UNITED STATES PATENT AND TRADEMARK OFFICE

Office Action Summary	Application No.	Applicant(s)
	10/626,412	GIBBS, DANIEL B.
	Examiner Chapman E. Jeanette	Art Unit 3635

DETAILED ACTION

FIG. 2

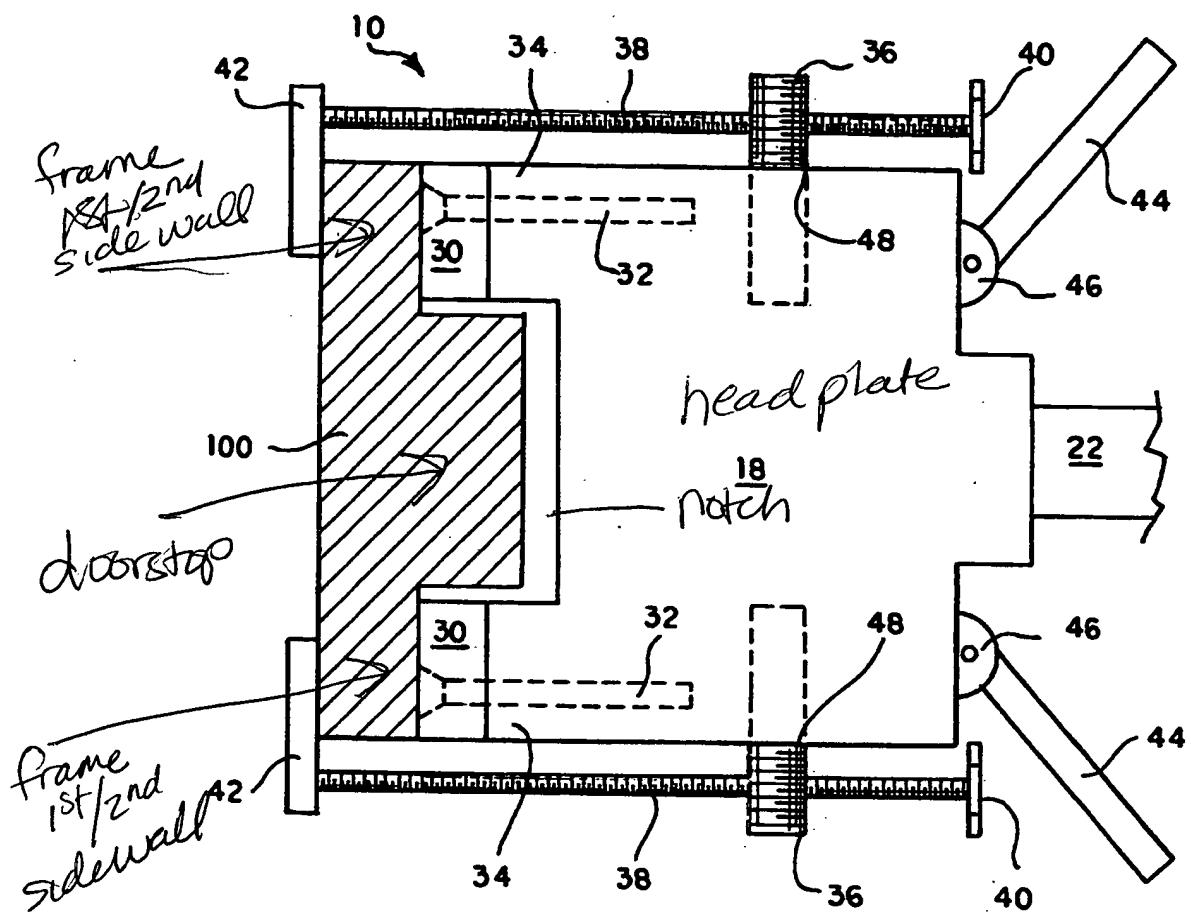
Claims 1-26(is/are) rejected under 35 U.S.C. 103(a) as being unpatentable over by Eicher, III (55340095) in view of Schworer (5653415) and Smith (Re. 32,815) Eicher, III discloses an apparatus for setting and maintaining the dimensions of a door frame comprising:

1. a first head plate 18
2. a first arm 22 connected to the first head plate
3. a second head plate 18
4. a second arm connected to the second plate
5. the second arm being adjustably engageable with said first arm
6. the first head plate includes a facing edge defining a notch, adjacent element 34, in a side opposite said connection to the first arm
7. the second head plate includes a facing edge defining a notch, adjacent element 34, in a side opposite said connection to the second arm
8. the first head plate includes a positioning finger 30 extending outward from a side of the facing edge in a direction opposite said connection to the first arm

9. the second head plate includes a positioning finger 30 extending outward from a side of said facing edge in a direction opposite said connection to the second arm

Most door frames obviously include opposing first and second sidewalls each having a doorstop mounted thereon. This structure is very common in the art of door frames. The first and second head plates of Eicher III would clearly engage a first/ second side walls of a frame and the first/second edge having a notch located for admitting the first and second doorstop mounted on the first side wall. See figure 2 and annotations on patented copy. Note: Most of the recited amended language is functional or intended use.
